## Part Change Notice: CE2\*\*\*\*Z0\* Female and Male Connector Abolition of Plastic Bag Packaging

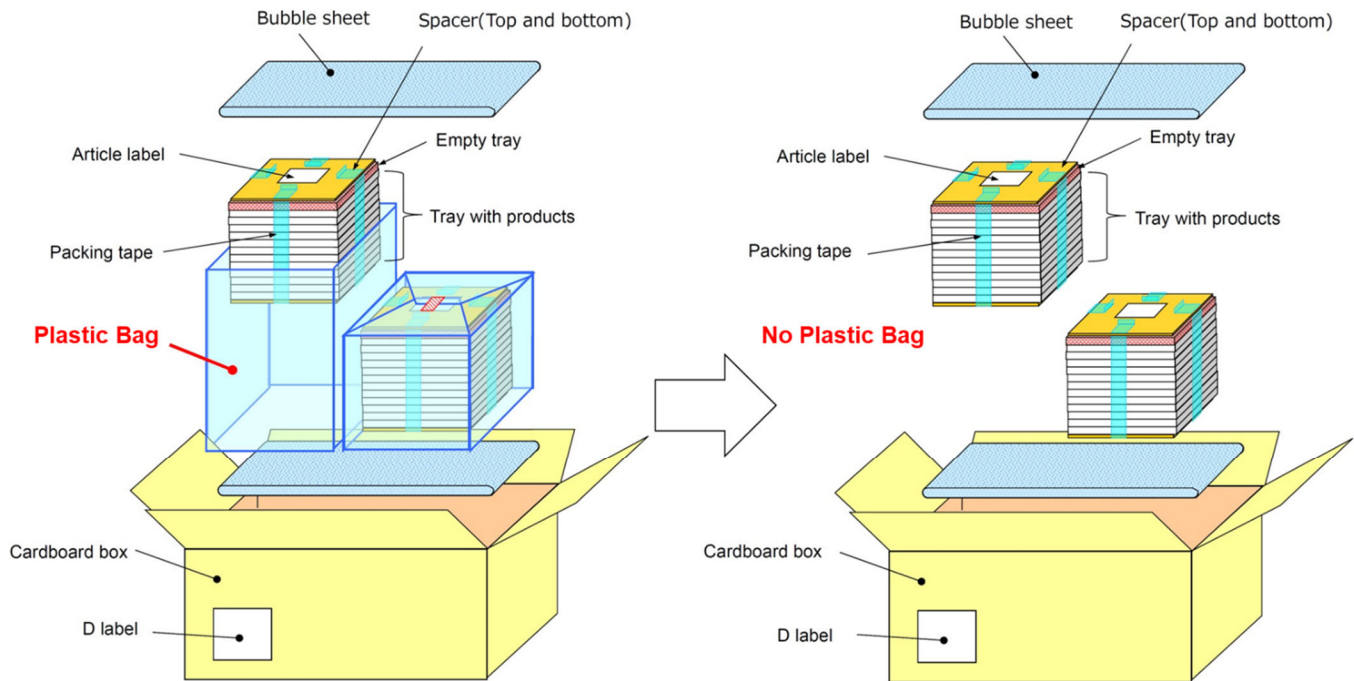
Currently, when packing CE2\*\*\*\*Z00 female connectors and male relays, each bundle is packed in a plastic bag. However, we have decided to discontinue plastic bag packaging as we no longer see the value in this method, and there is no difference to the connector's performance without it.
